**SIB 65 05 18**

AIR BAG LAMP ILLUMINATED. FAULT CODE 9309A0This Service Information Bulletin (Revision 5) replaces SI B65 05 18 **dated February 2020**.**What's New** (Specific text highlighted):

- Model Section – Production date range specified
- Cause, Correction Section – Updates for no programming if applicable
- Claim Section - The limited warranty coverage for this repair procedure has been extended to 10 years/120,000 miles

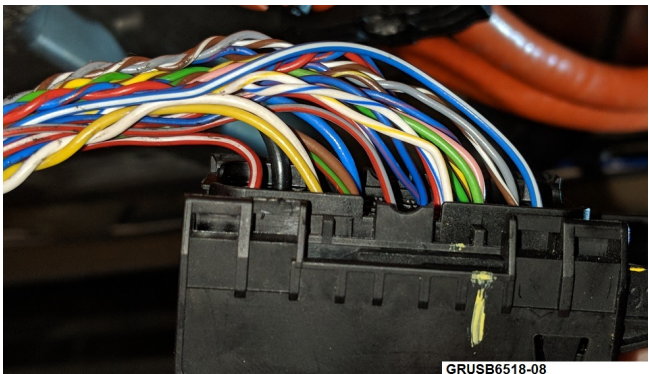
7. These two bottom wires (white & yellow) need to have some tension relieved on them.

- Remove the last 8" of tape from the harness at the EME connector to introduce some stress relief into this connection at the EME

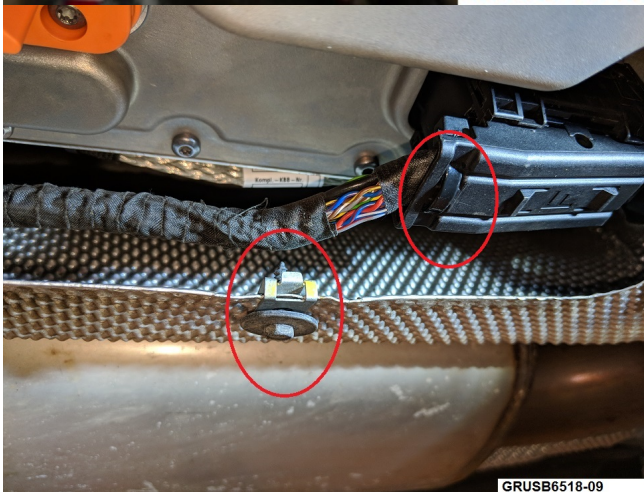
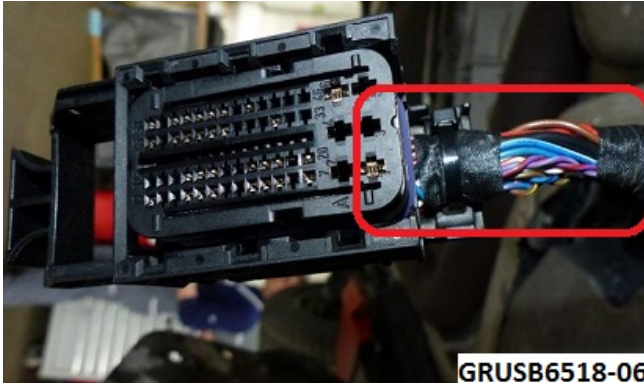
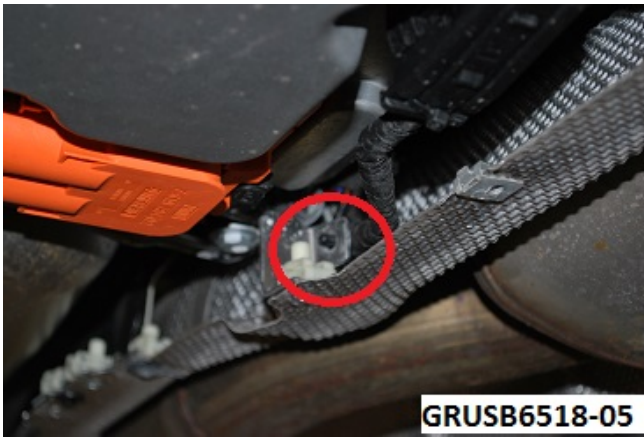
8. The wires between the zip tie location and the EME electrical connector/pins should **NOT** be under tension!

The wires now have a strain relief loop to eliminate tension on the electrical pins.

9. If you need more slack at the connector, go back to the last body tie down approx. 6" (16 cm) back from this EME connector, and pull some slack from there.

10. Place two wraps of tape around the wiring under where the zip tie will go over the wiring harness.

- There should be a 2"+ gap between this wrap around the harness and where the harness wrap begins

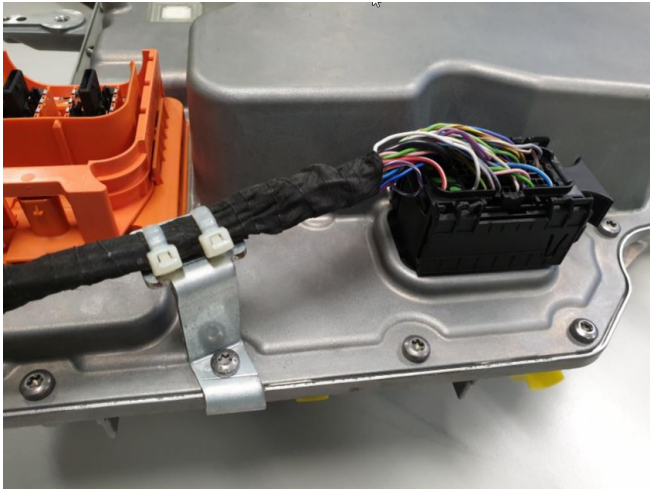
11. When you reinstall the zip tie on the cable on the end of the EME connector, point the end of the tie upwards so it can't rub on the underbody panel of the vehicle (circled).

Also check to make sure there is still tension on the harness so that it won't droop and touch the top of the underbody panel hold-down screw (circled).

12. Remove bolt from EME. Install the new angle bracket and screw into the EME as shown here.

- 61 13 4 A03 DB3 Angle Bracket
- 61 25 7 621 147 Screw

The screw must be **torqued to 8.5 Nm**.
